DEVELOPMENT NO.:	24019750
APPLICANT:	JAM Constructions Pty Ltd Trading as James Michael Homes Pty Ltd
ADDRESS:	10 CROSBY ST SOUTH BRIGHTON SA 5048
NATURE OF DEVELOPMENT:	Construct a 2 Storey Dwelling, with retaining walls up to 1.6m
ZONING INFORMATION:	<p>Zones:</p> <ul style="list-style-type: none"> • General Neighbourhood <p>Overlays:</p> <ul style="list-style-type: none"> • Airport Building Heights (Regulated) • Affordable Housing • Prescribed Wells Area • Regulated and Significant Tree • Stormwater Management • Urban Tree Canopy
LODGEMENT DATE:	8 Jul 2024
RELEVANT AUTHORITY:	Assessment Panel at City of Holdfast Bay
PLANNING & DESIGN CODE VERSION:	P&D Code (in effect) Version 2024.12 04/07/2024
CATEGORY OF DEVELOPMENT:	Code Assessed - Performance Assessed
NOTIFICATION:	Yes
RECOMMENDING OFFICER:	Michael Gates Development Services (Planning and Building) Lead
REFERRALS STATUTORY:	None
REFERRALS NON-STATUTORY:	None

Image showing the upper level

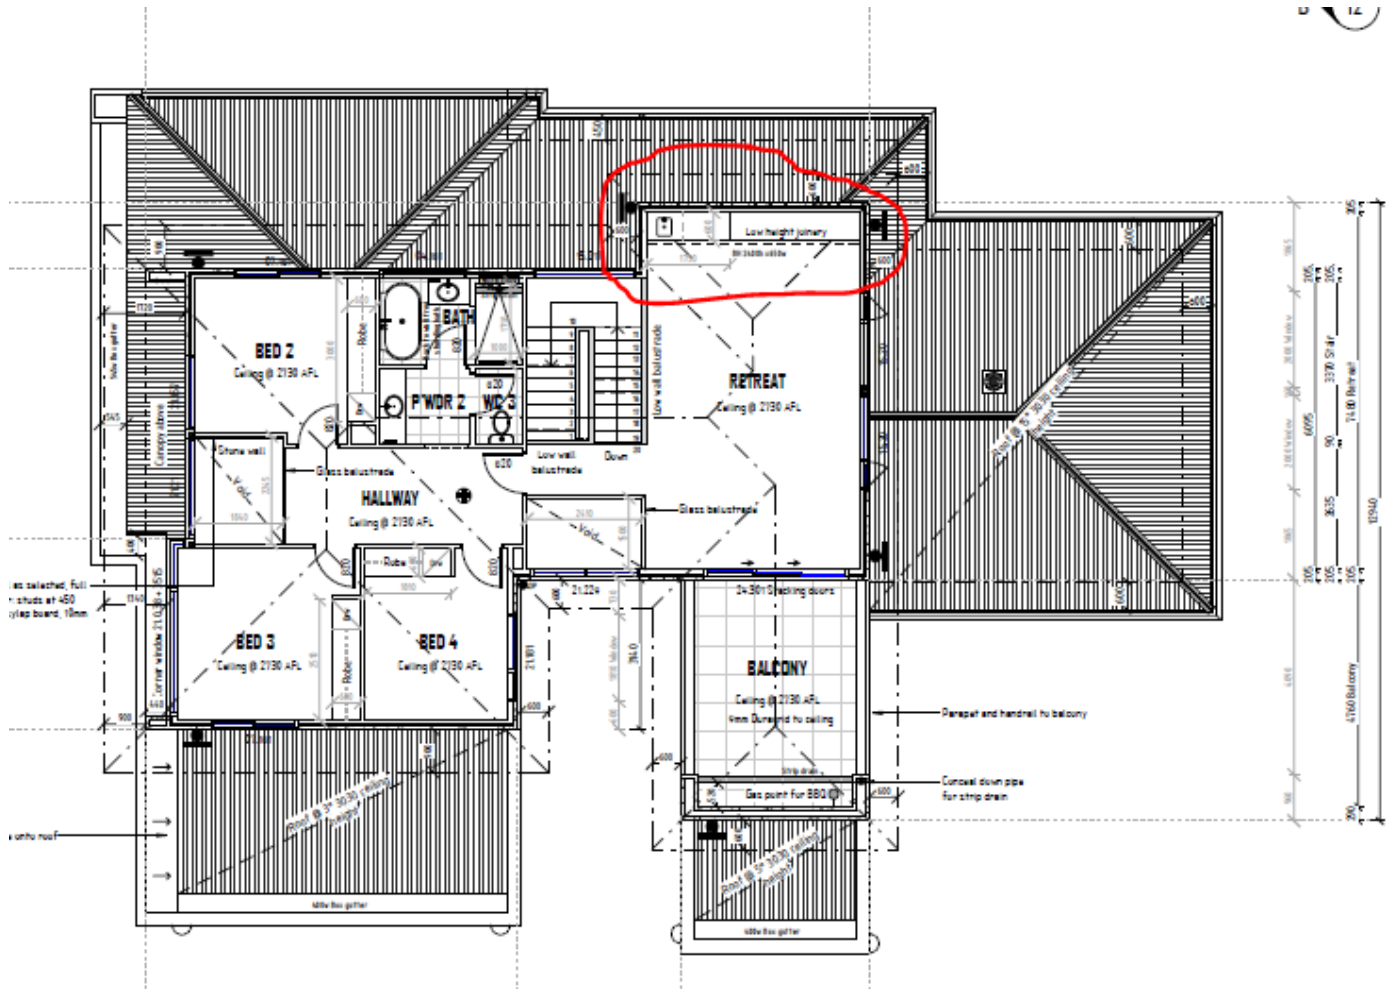
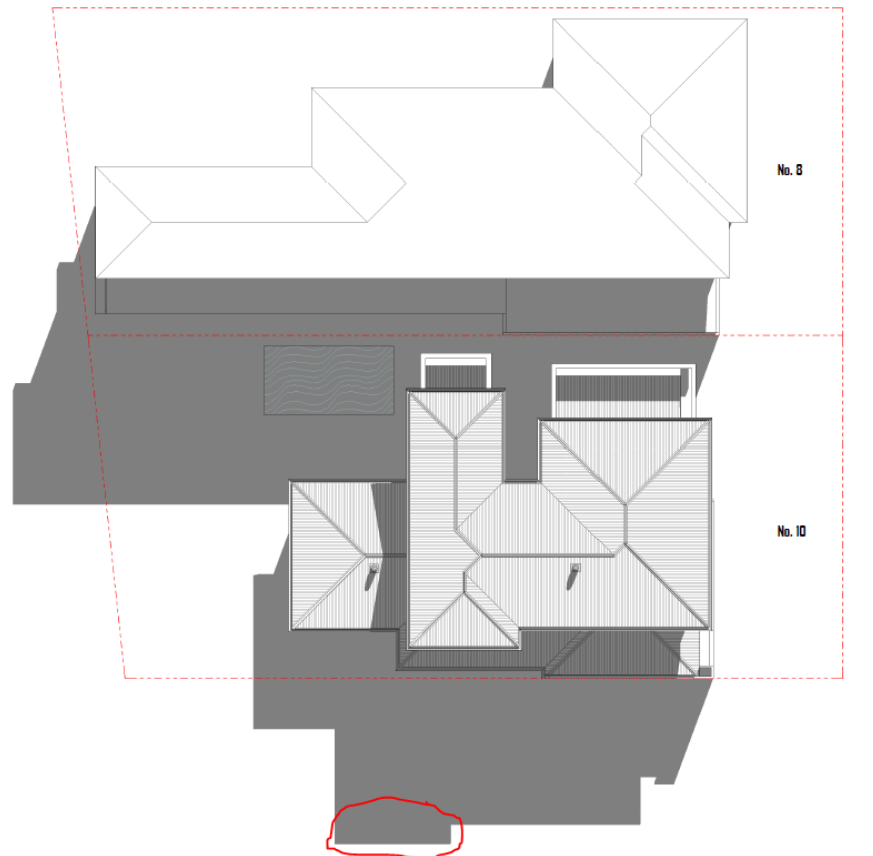
The proposal satisfies all of the Desired Performance Features requirements in regards to setbacks except for a small portion of the upper level on the southern side. The front setback, rear setback and side setbacks will all complement the existing setback patterns. The large rear setback provides a large amount of private open space and separation between the neighbouring dwellings.

Most of the upper storey is set 3.8 metres from the southern boundary, with a small section set 2.4 metres, with the area circled in red below.

Shadow Diagram

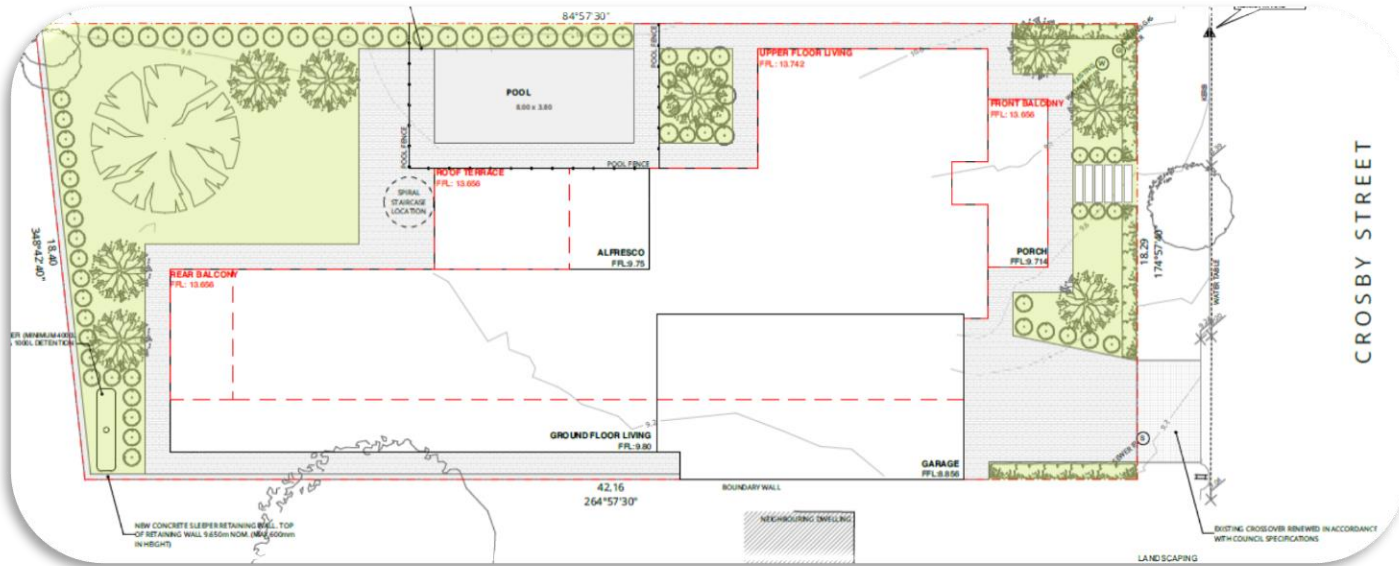
The applicant has provided an overshadowing diagram which demonstrates there is little difference in overshadowing between the area that has a compliant setback, and the area which has a shortfall. The proposed area that protrudes closer to the boundary is considered not to be visually dominant and given the limited additional overshadowing, is considered reasonable in this instance.

The image below has the shadow caused by the protruding upper storey area circled in red. This diagram shows the additional overshadowing is of a minor difference.

Site plan of the adjacent dwelling to the north showing no areas of private open space visible from the south

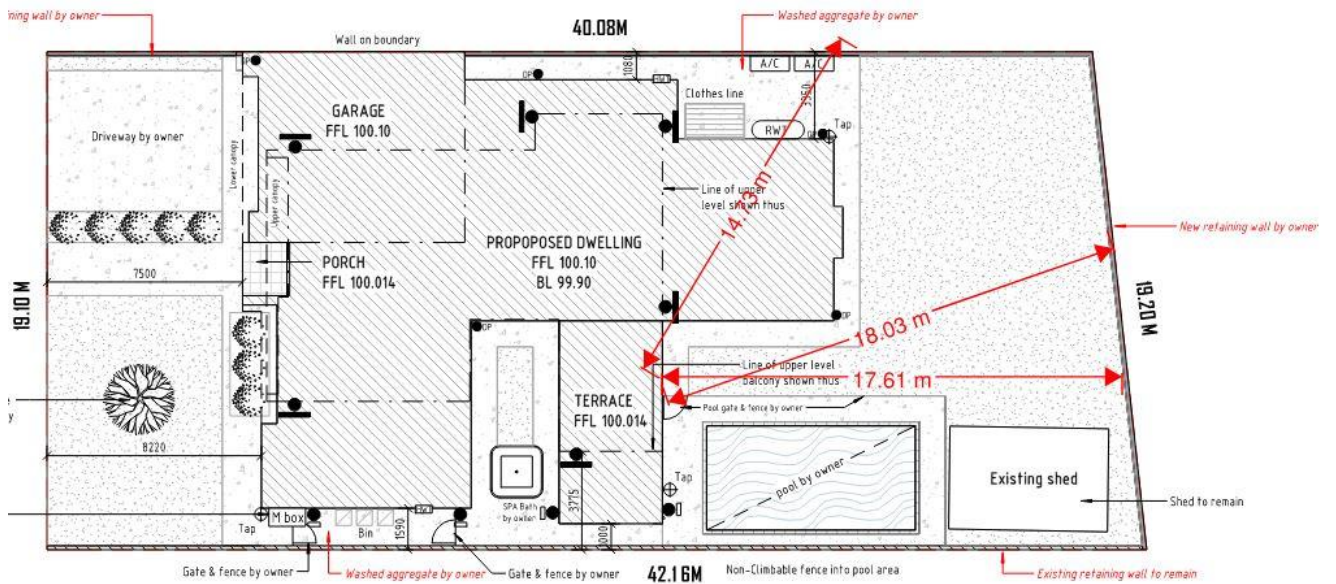
The proposal includes an upper-level balcony on the northern side of the dwelling that does not include screening. The design is considered reasonable in this instance given there will be no direct overlooking to the north due to the orientation of the dwelling to the north and western boundary is located more than 15 metres away. As outlined in Code, privacy measures are not required for private open space areas more than 15 metres away. A site plan of the neighbouring property to the north is shown below demonstrating the balcony will not overlook the adjacent dwelling.

A standard condition is included in the recommendation in regards to window treatment to maintain privacy to neighbouring properties as there are upper storey windows that may overlook adjacent dwellings at the rear of the upper level.
